Subject: Fuel Tank System Design Review, Flammability Reduction, and Maintenance and Inspection Requirements. • Notice of Proposed Rulemaking

**Aviation Industry Response
to
FAA NPRM 99-18**

Transport Airplane Fuel Tank System Design Review,
Flammability Reduction, and
Maintenance and Inspection Requirements

Figure 1

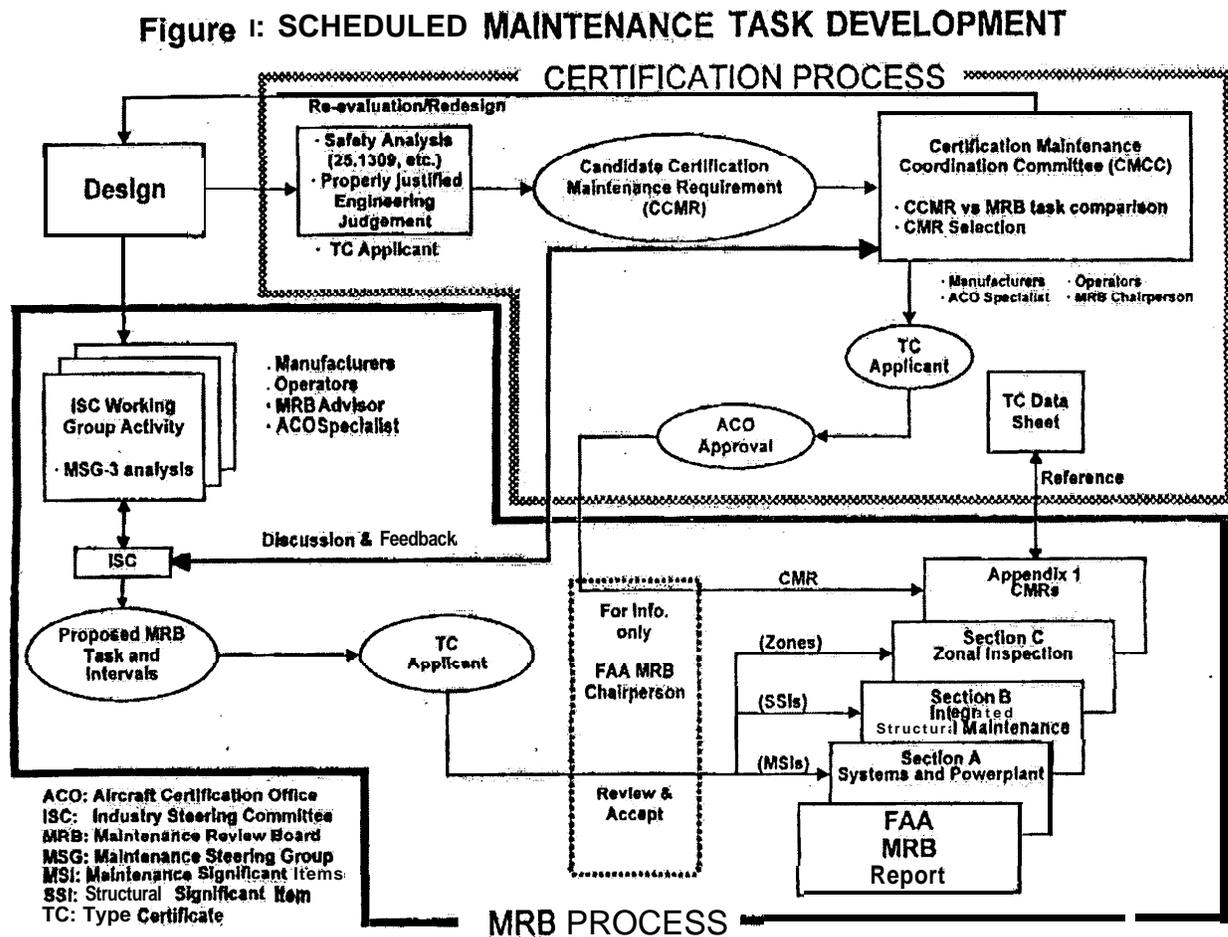
Considering the above, the industry believes that the only way to produce a fuel tank maintenance program that enhances safety and remains economically feasible is to use the Certification Maintenance Coordination Committee (CMCC) as defined in the AC 25-19 diagram titled *Scheduled Maintenance Task Development* (see figure 1).
